PROJECT NO. PR-2021-006070
Application No. SI-2021-01888

DESCRIPTION: Comment response memo, revised plan set, and infrastructure list.

Memorandum

Re: Westpointe40 South Site Plan DRB Comment Responses (PR-2021-006070)

ACCESSIBLE PARKING DETAIL

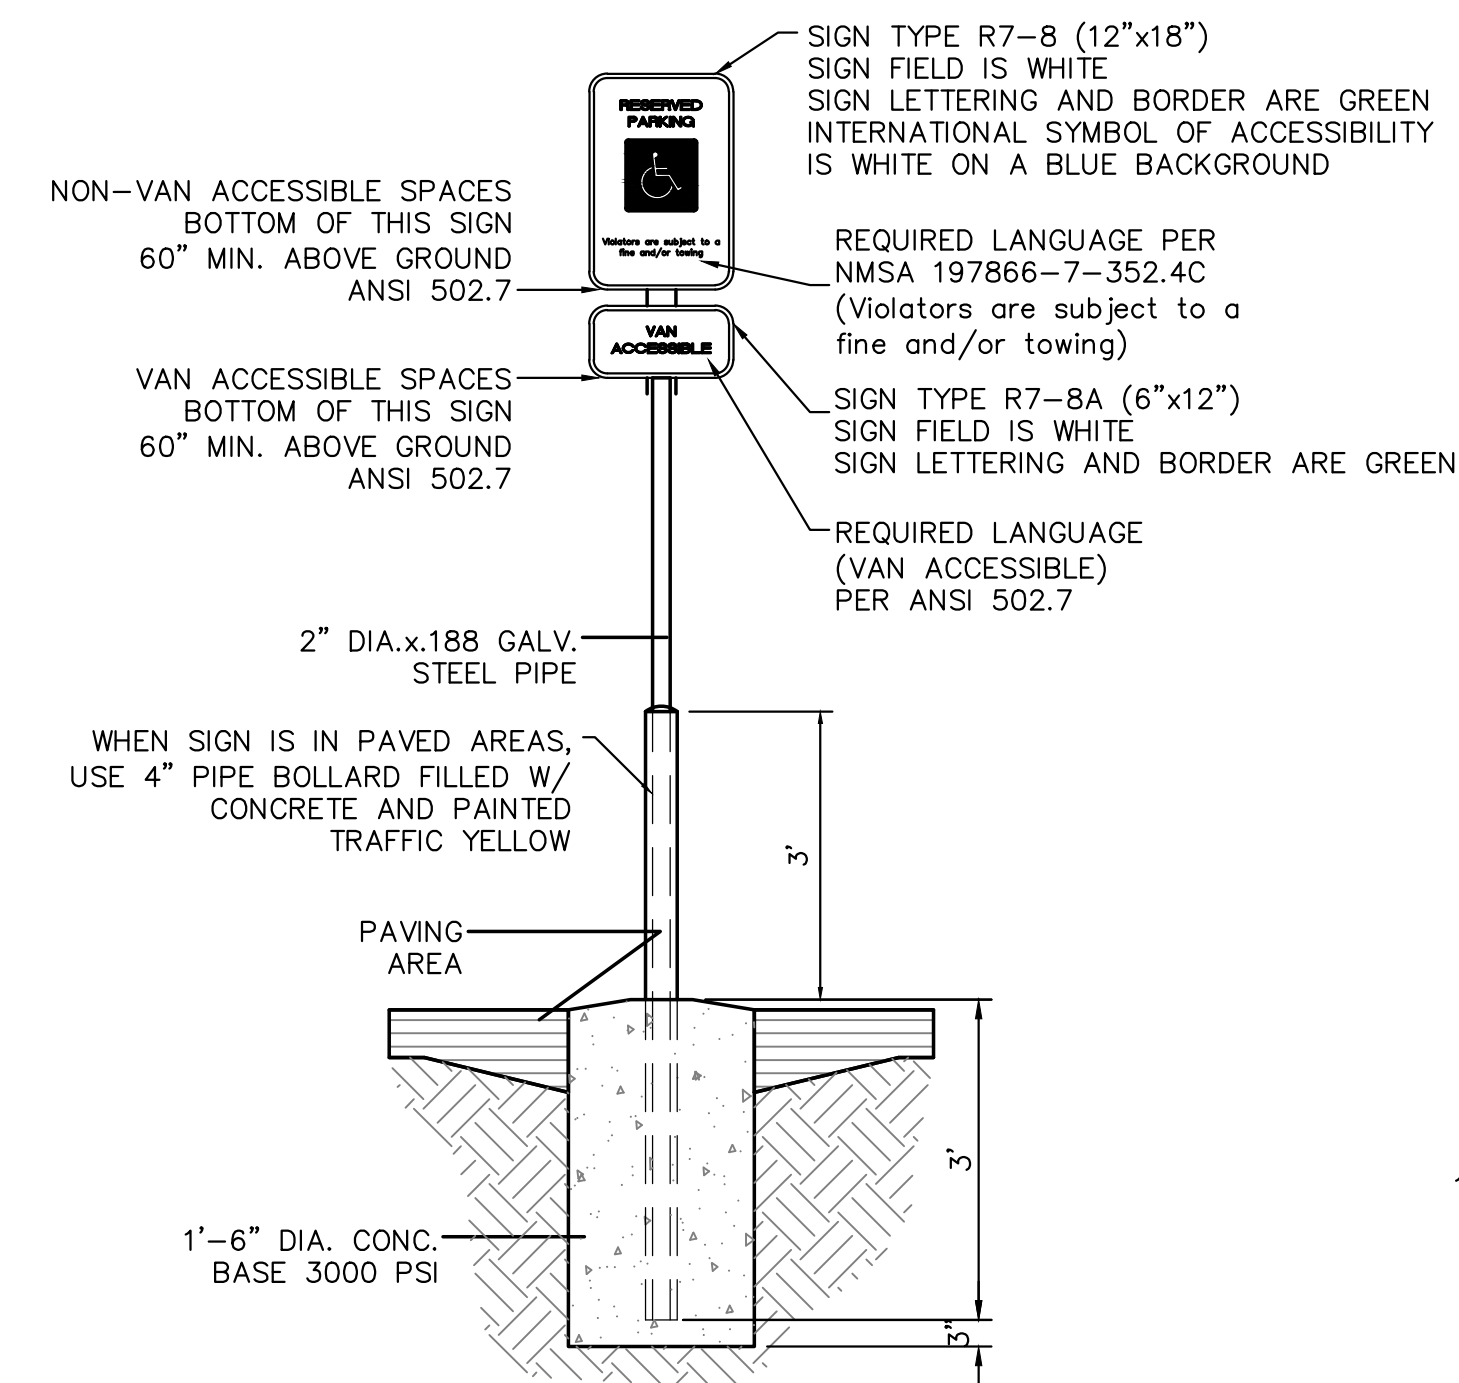
- *The details sheet has been updated to specify the cross slope.*
5. On the curb ramp detail for van accessible aisle provided, include dimensioning or specify

minimum required dimensions for both the ramp and area between the ramp and building. At minimum, a 4-foot by 4-foot space is required for turning behind the wheelchair ramp.

- *A note has been added to the accessible parking/curb ramp detail specifying the minimum dimensions required between the ramp and building.*

MINIMUM REQUIRED AREA OF 4'x4' REQUIRED AT THE TOP OF RAMP FOR TURNING MOVEMENTS BETWEEN RAMP AND BUILDING OR ANY OTHER OBSTRUCTION

CONCRETE SIDEWALK SECTION

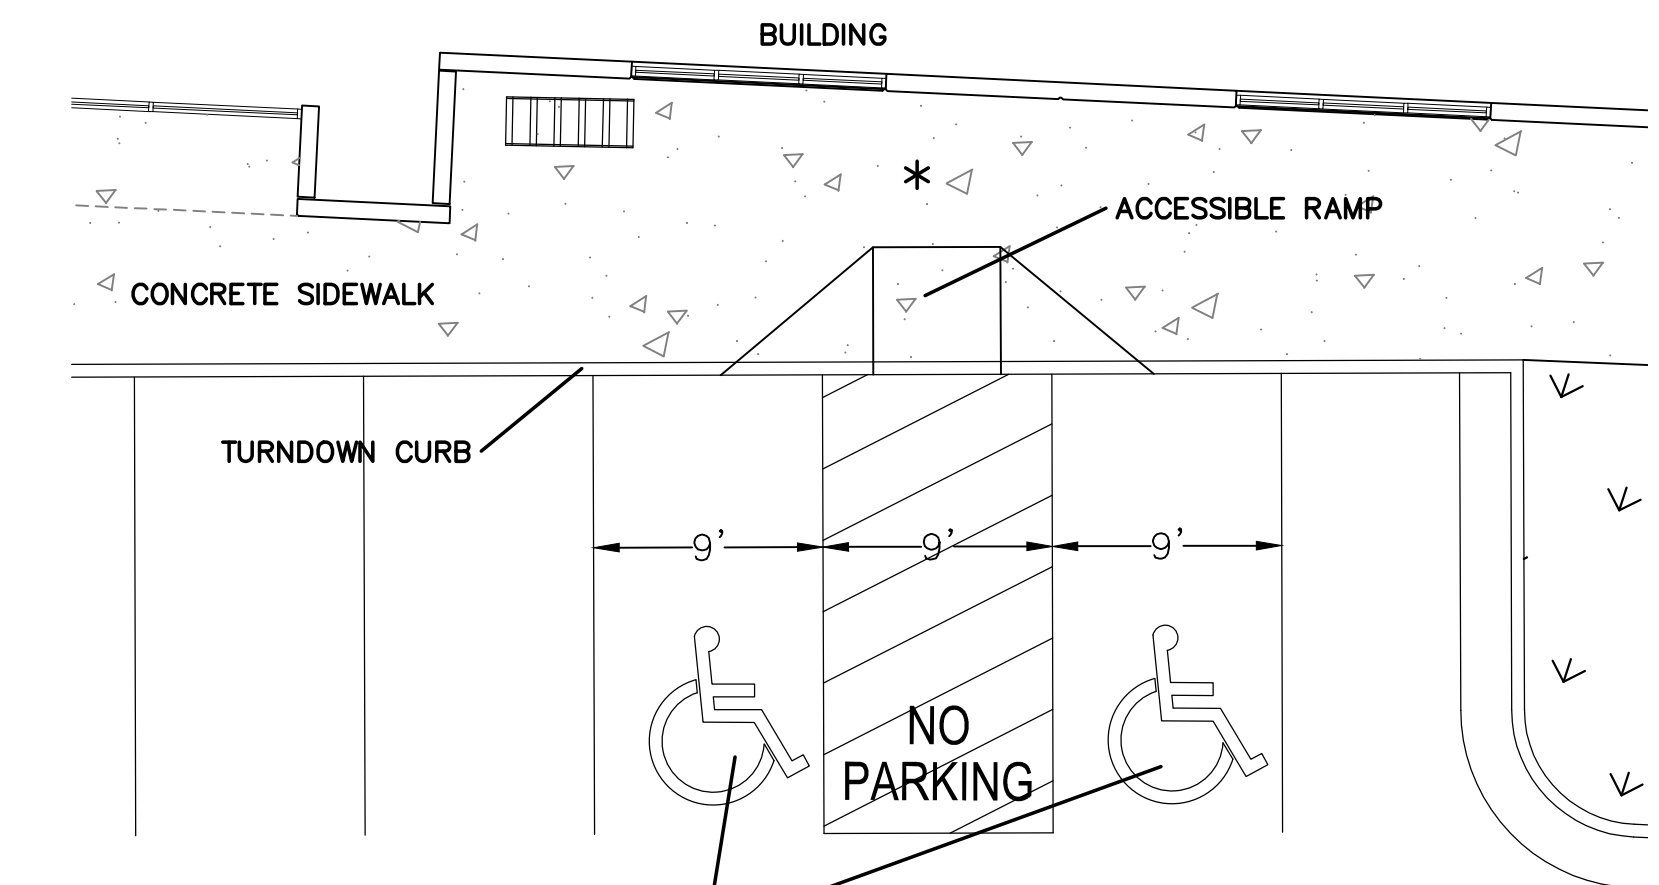
3. Obtain Fire-1 plan for the submittal set.
 - *The approved Fire 1 plan has been added to the attached plan set.*
4. Include the sidewalk detail in the Det-1 sheet, showing a 2% maximum cross-slope.

BLUE SKY DISTRIBUTING ALBUQUERQUE, NM	DRAWN BY pm
	CONCEPTUAL GRADING AND DRAINAGE PLAN	DATE 12-6-21
	5571 MIDWAY PARK PL NE ALBUQUERQUE, NEW MEXICO 87109 (505) 858-3100 www.tierrawestllc.com	DRAWING 2020088-60K.DWG
RONALD R. BOHANNAN P.E. #7868	12-6-21	SHEET # GR-1
		JOB # 2020088

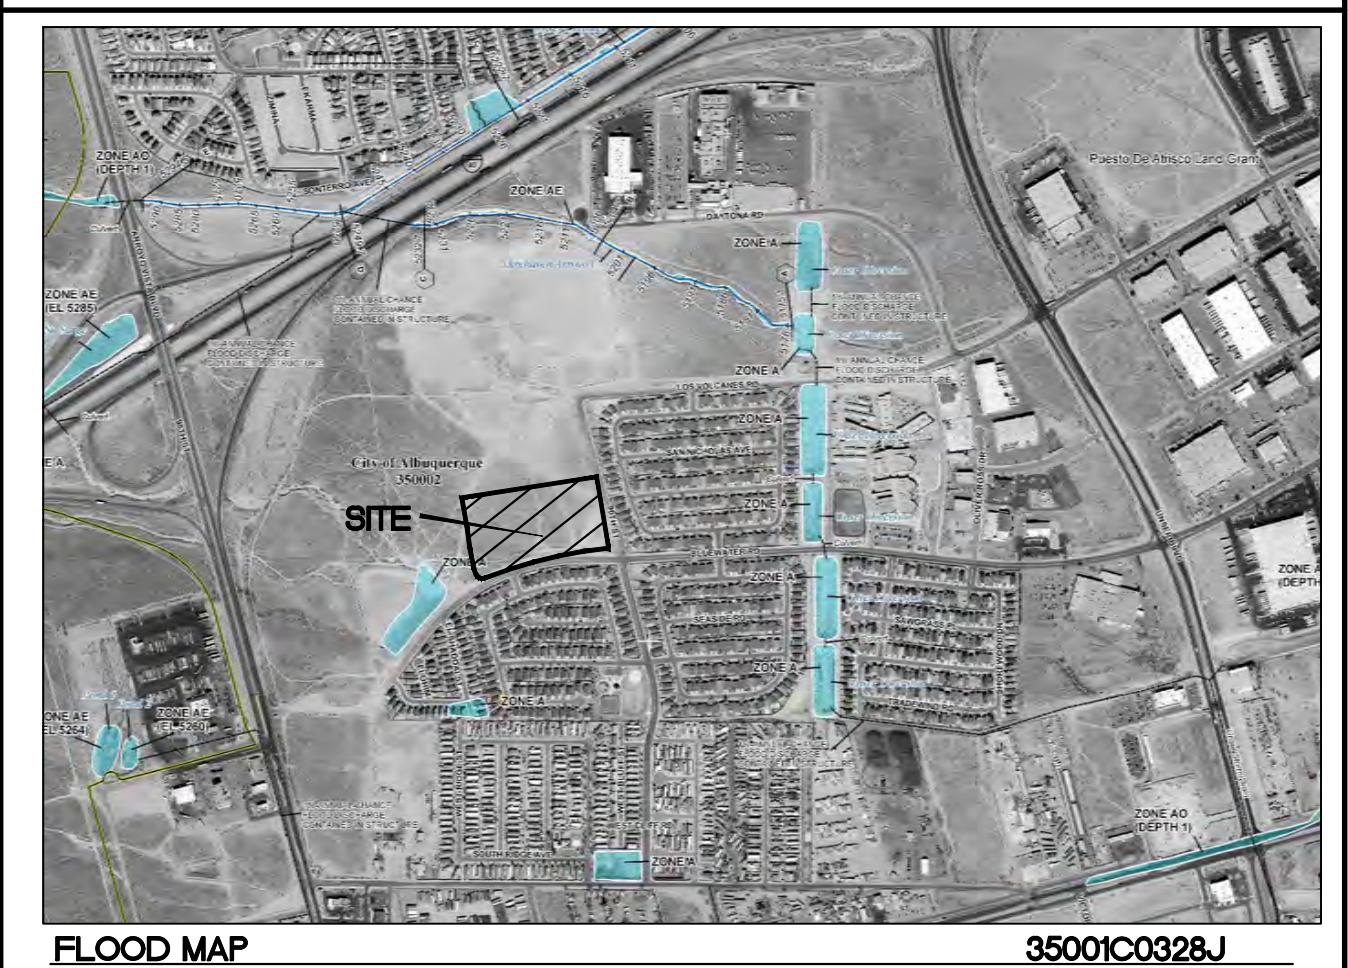
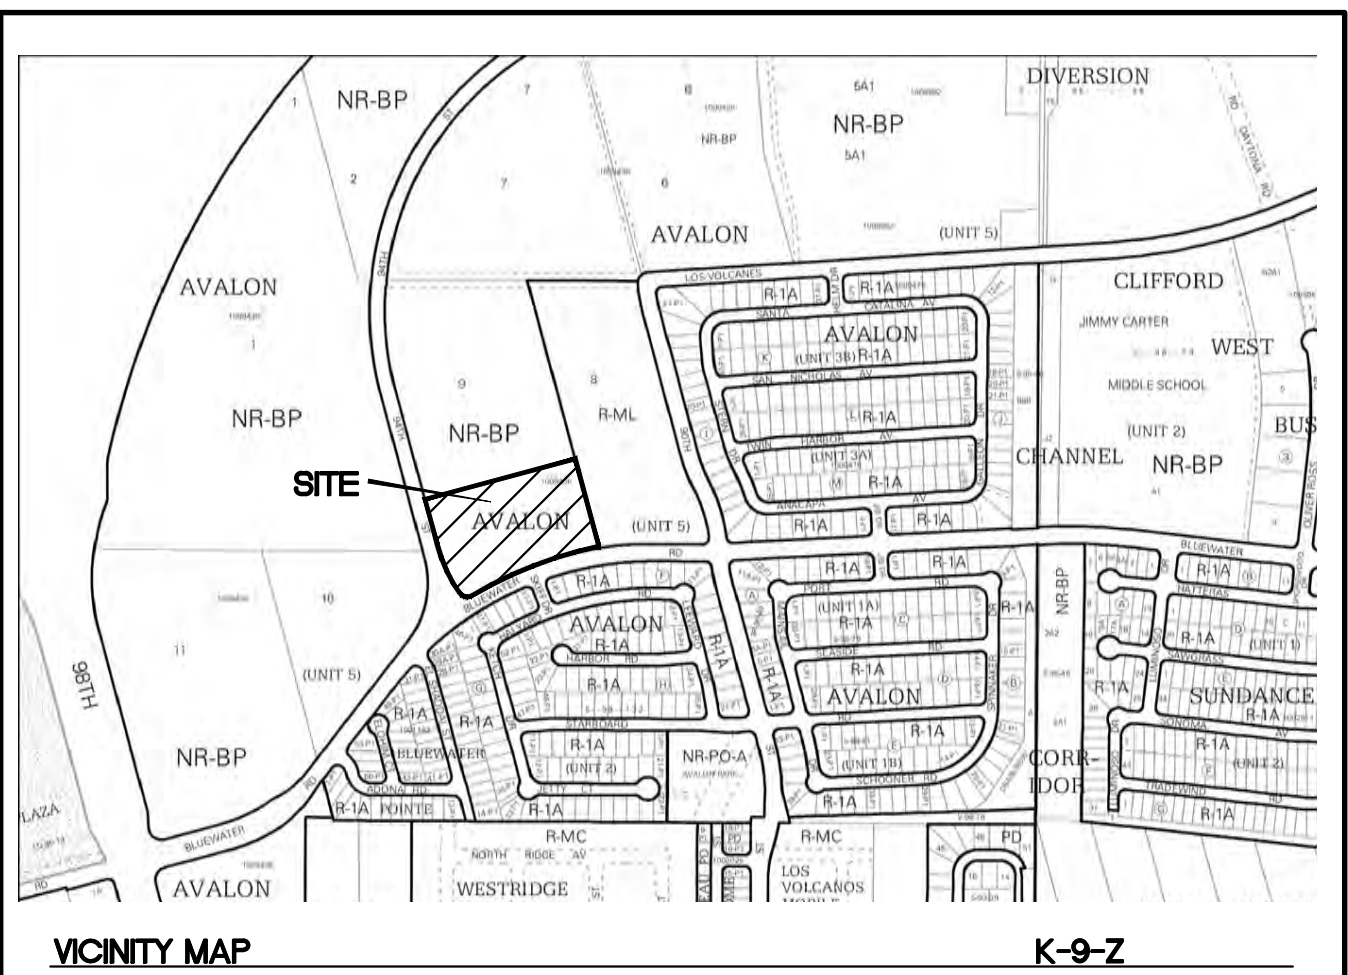
1. Hydrology did receive the submittals for both the North Tract and the South Tract on 11/04/2021 (K09D050 – South Tract & K09D051 – North Tract). Currently these are #6 & 7 in the queue and will be looked at some time the week of December 27th.
 - a. *The Applicant received approval of the referenced grading and drainage plans. The approval letter is attached, and the stamped sheets are included within the updated plan set.*

BLUE SKY DISTRIBUTING ALBUQUERQUE, NM	DRAWN BY pm
	CONCEPTUAL MASTER UTILITY PLAN	DATE 12-22-21
	5571 MIDWAY PARK PL NE ALBUQUERQUE, NEW MEXICO 87109 (505) 858-3100 www.tierrawestllc.com	DRAWING 2020088-60K-MU.DWG
RONALD R. BOHANNAN P.E. #7868	SHEET # MU-1	JOB # 2020088

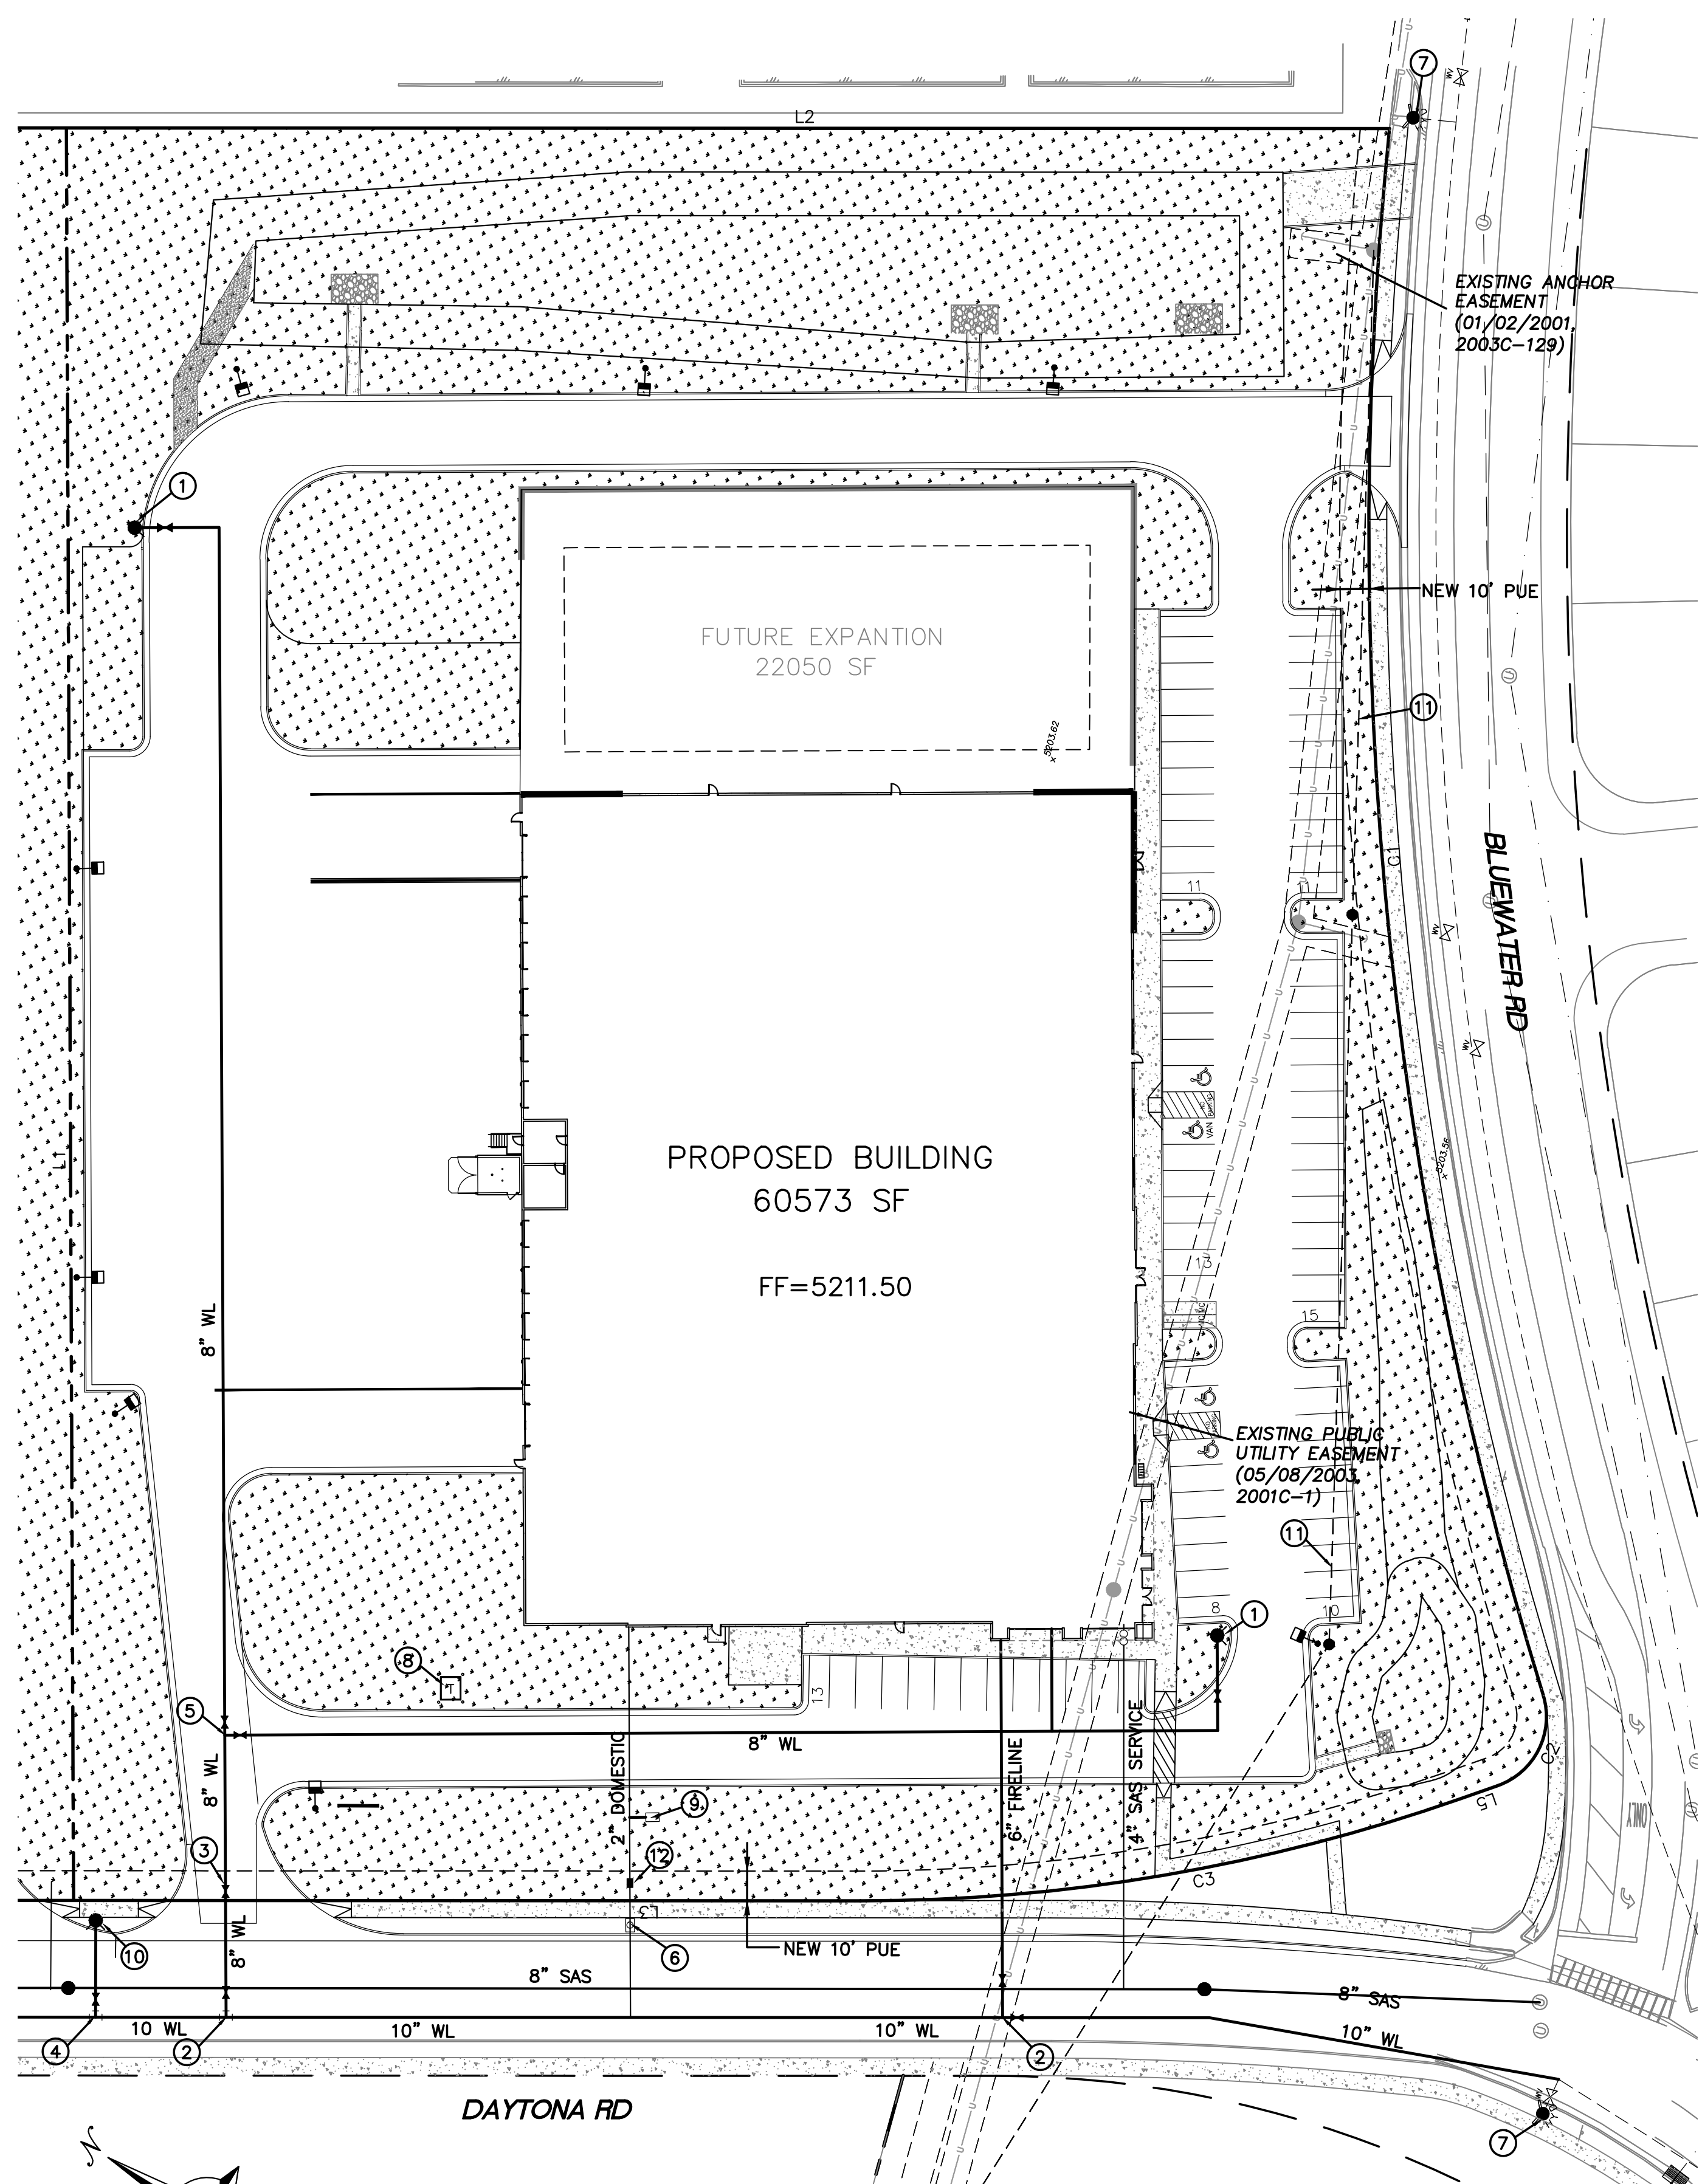
1. Availability Statement #210915R has been issued and provides the criteria for service. Extensions are required.
 - *Understood. An infrastructure list is included with the site plan.*
2. This project is within the adopted service area.
3. Pro rata is not owed for this property.
4. Utility Plan:
 - a. The backflow device should precede any other branches in the service. This should be before the separate to the irrigation yard lines.
 - *An updated utility plan has been provided with the supplemental submittal showing the backflow device before the split to the irrigation line.*
